PROJECT NAME: **Renovations for Scotland Town Hall
9 Devotion Road Scotland, CT 06264**

ADDENDUM NUMBER FIVE

This addendum forms a part of the bidding and contract documents for Renovations for Scotland Town Hall. It modifies the original bidding documents prepared by Nelson Edwards Company Architects LLC dated February 20, 2026.

Map of Soil Test Data

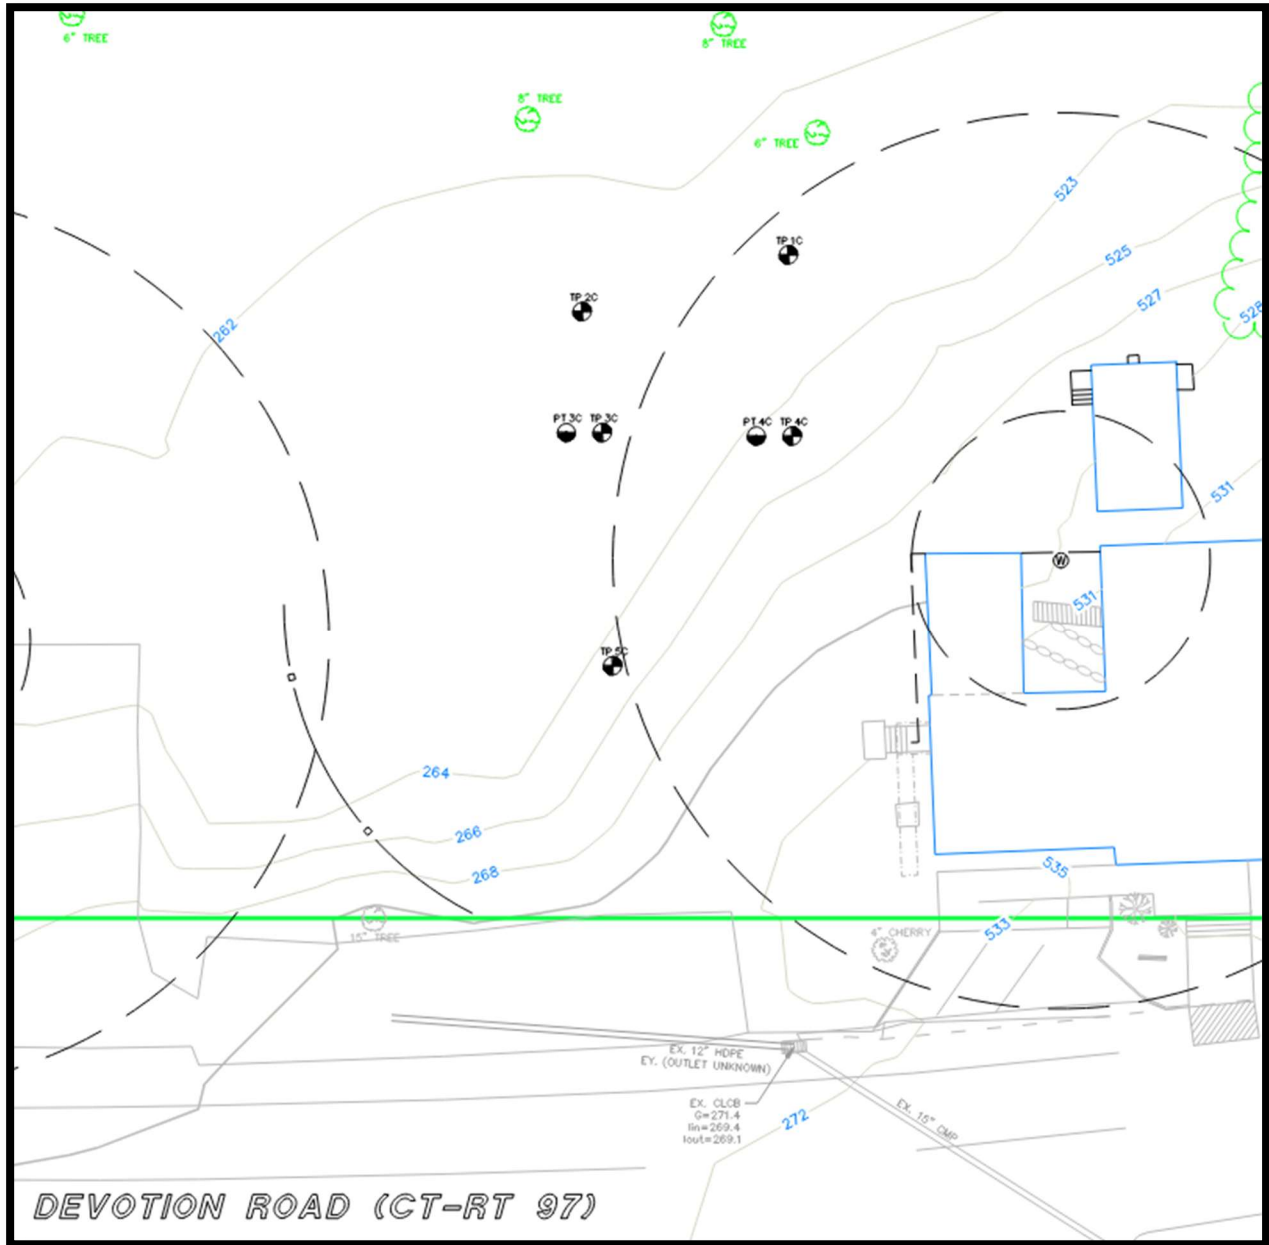
6.		<p>Q: Please provide soil borings, test pits, groundwater data, and infiltration rates or a geotechnical report.</p> <p>A: <i>Soil testing was conducted for the purpose of septic system repairs completed by the Town. See Attachment 'A' to this Addendum for soil test results and location map for testing locations.</i></p>

15.		Q: Please confirm anticipated groundwater conditions? A: <i>Based on available soil testing results, it was observed that groundwater seepage occurred at various depths from 47" to 77" but was dependent on where the testing occurred. See Attachment 'A', Soil Test Data.</i>

Scale Project No. 24004.00 Date 4/16/26 Rev.	PROJECT Renovations for Scotland Town Hall Scotland, CT	SKETCH TITLE Dtl. Allied Window Magnetic One-Lite	 NELSON + EDWARDS COMPANY ARCHITECTS, LLC 1156 MAIN STREET BRANFORD, CONNECTICUT 06405 (203) 481-6611 Fax (203) 481-1992	BSK 1 SHEET OF
CONSULTANT

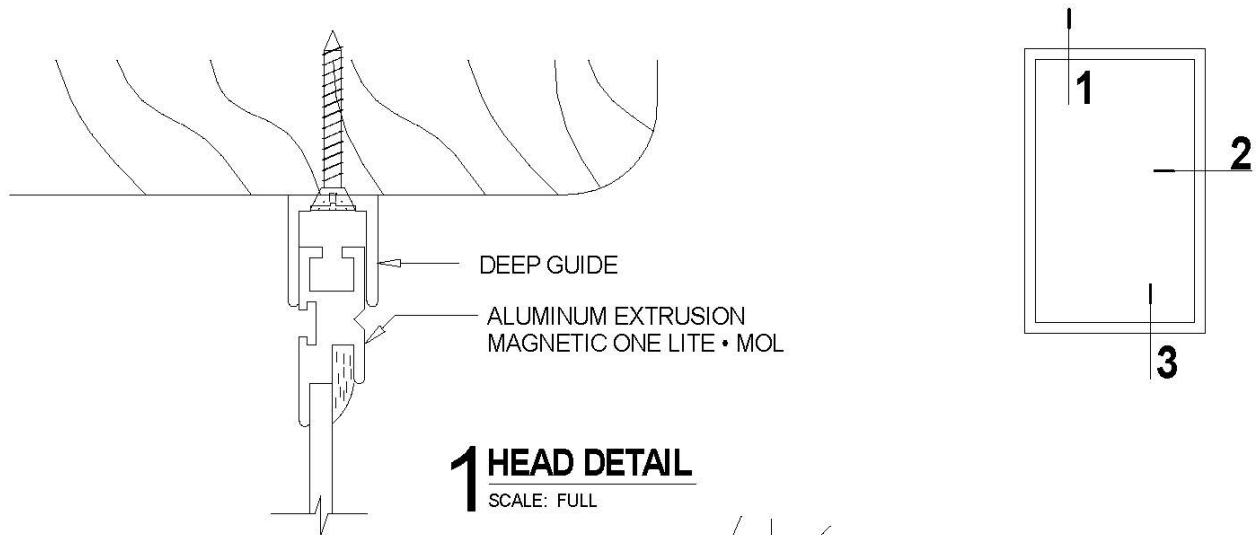
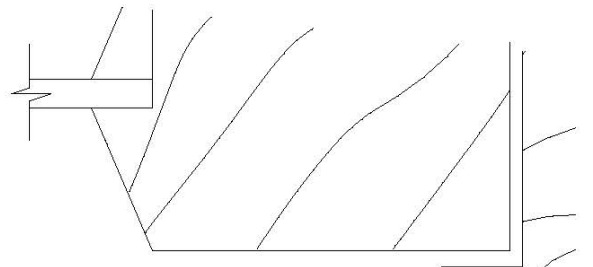
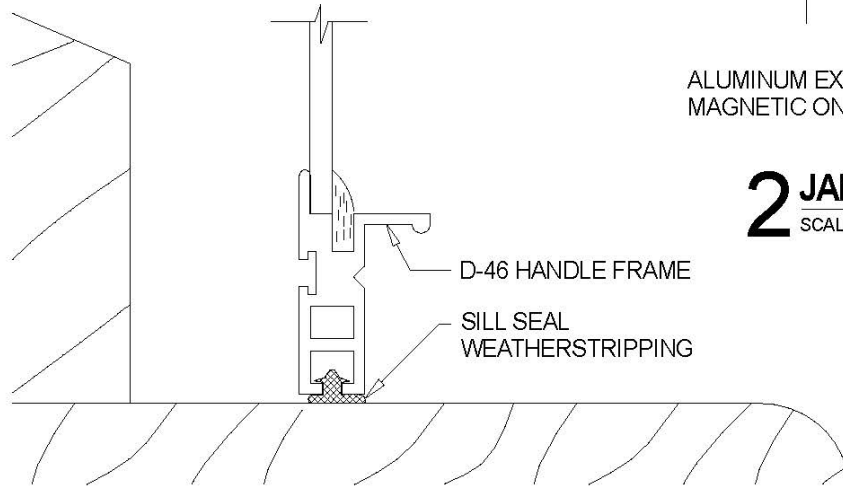
57.	01 55 26 Traffic Control (ADD)	This section is added to the Project Manual for work within the State right-of-way.
58.	08 58 01 Custom Metal Storm Windows (CLARIFY)	Magnetic Storm Windows are: Allied Window, Inc., Magnetic One Lite per section 08 58 01. Glazing at windows N1.1 and N1.2 to be obscure glass. Detail 1/A-600 is revised. BSK-1 issued to replace 1/A-600. Review Note 3 Under Window Schedule on A-600 to read 'storm window system: Allied Window Inc. (Cincinnati, Ohio) Magnetic One Lite interior storm.'

This detail replaces I/A600 and is for Magnetic One Lite Single Storm Panel
